METROPOLITAN GOVERNMENT OF NASHVILLE AND DAVIDSON COUNTY

STAFF RECOMMENDATION 1810 Ashwood Avenue January 15, 2013

Application: Demolition
District: Belmont-Hillsboro Neighborhood Conservation Zoning Overlay
Council District: 18
Map and Parcel Number: 10416007800
Applicant: Andrew Oeltmann, owner
Project Lead: Robin Zeigler, robin.zeigler@nashville.gov

<p>Description of Project: The applicant proposes to demolish a contributing historic building to the Belmont-Hillsboro Neighborhood Conservation Zoning Overlay based on economic hardship.</p> <p>Recommendation Summary: Staff recommends disapproval of the project based on the fact that the building is historic therefore meeting section IV.B.a for inappropriate demolition and the fact that the building is habitable with simple repairs and therefore does not meet section IV.B.a-c for appropriate demolition.</p>	<p>Attachments A: Correspondence B: Photographs C: Rehab Estimate D: Engineer's Report E: Additional Info</p>
--	---

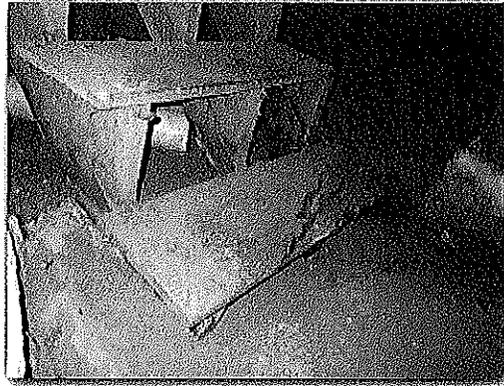
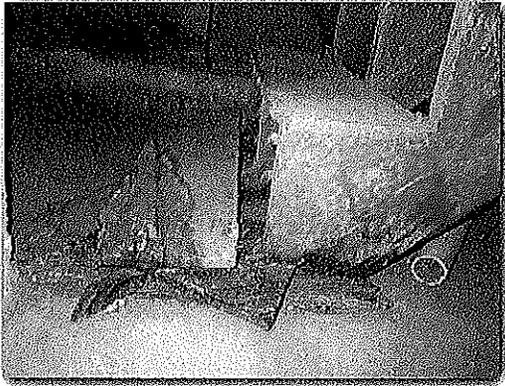
The back-left bedroom addition is built over a concrete slab which does not have a turned-down edge or perimeter footing. As a result, differential settlement has occurred. This settlement is most pronounced along the left side, lower left photo, where the slab has rotated downward under the left wall. This settlement has rotated the right edge of the slab, at a crack, upward approximately 7/8ths of an inch, lower right photo and arrow in lower left photo.

The foundation for this addition needs to be re-built. A suitable concrete perimeter footing at least 12 inches below grade, at least 18 inches wide and 12 inches thick with two #4 rebar, needs to be provided. The foundation wall needs to be built on top of the footing in a permanent manner such that the ground will be at least six (6) inches below any wooden wall framing.

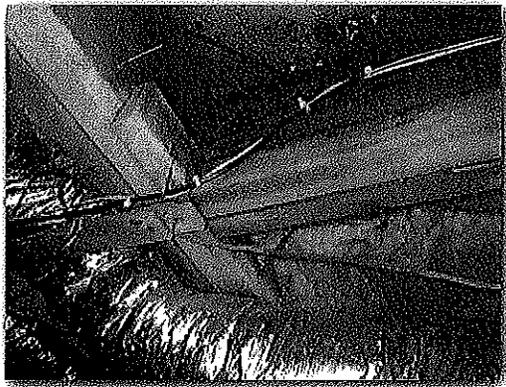
There is an un-supported intersection of two double joists or girders located above the base of the stairs which is not provided with a support post, lower left photo.

The doubled joist should be provided with a hanger bracket or a support post should be installed to support this connection.

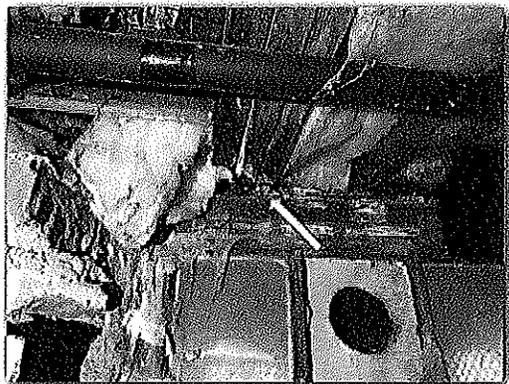
There is wall cracking in the left wall of the back-right bedroom. This wall is supported by a triple floor joist in the basement. The back end of this joist is improperly supported above a back basement window, lower photo. which has allowed the joist to settle. A proper double 2x8 header needs to be installed at the end of this joist across the window.

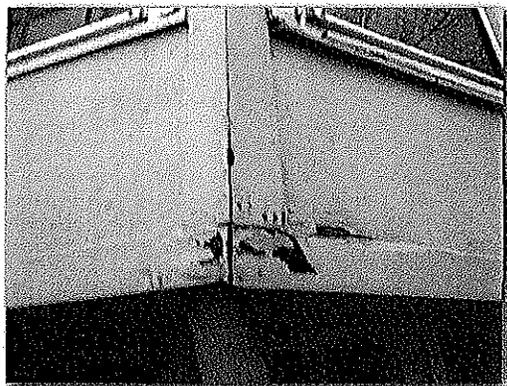
The exterior siding of this building consists of wood siding which has been painted. There are several areas around the house where deferred maintenance has caused significant rot in the siding. Examples are shown in the following photos. The rotted siding needs to be removed so that the extent of the damage can be determined and all rotted framing also replaced.

Many of the wooden windows also have significantly rotted trim. Examples are shown in the following photos. These windows are rotted to the point that water is entering the structure and most likely wood framing rot has occurred. Not only do the windows need to be replaced, but wall framing rot will need to be repaired.
